Service Information

Category S	Repair Guidance	Ref. No. R021/13	Page 1 of 6
Coverage <input type="checkbox"/> Distributor only <input checked="" type="checkbox"/> Please inform your dealers		Date Issued March 13, 2013	
Please convey this information to your <input type="checkbox"/> Director <input checked="" type="checkbox"/> General Manager <input checked="" type="checkbox"/> Warranty Dept. <input checked="" type="checkbox"/> Parts Dept. <input checked="" type="checkbox"/> Training Dept. <input checked="" type="checkbox"/> Field Rep.		Date Revised	
Applicable Model Mazda6 (GJ)		Applicable Countries or Specifications Worldwide

Subject: Rattle Noise from Passenger side Instrument Panel

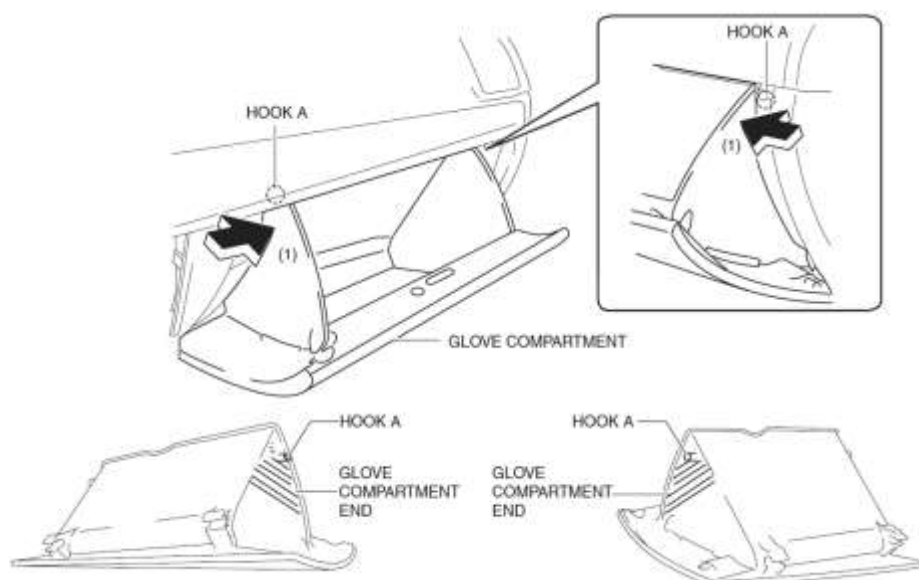
The bracket C on the passenger-side air bag and bracket holder on the instrument panel interfere and make a rattle noise when driving on a rough road.

The felt size and attaching point on the bracket holder have been changed.

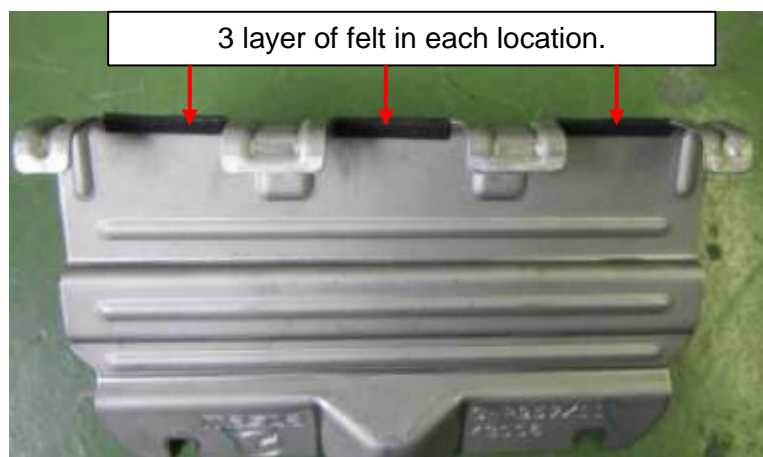
9. Select a sheet of pad in 0.25mm thickness from the “Noise Parts Set” and cut it to the following size.
- 9 pieces of 10 X 33 mm size

10. Attach the felts to the 3 location of Bracket C as below, and apply 3 pieces in layer at each location.
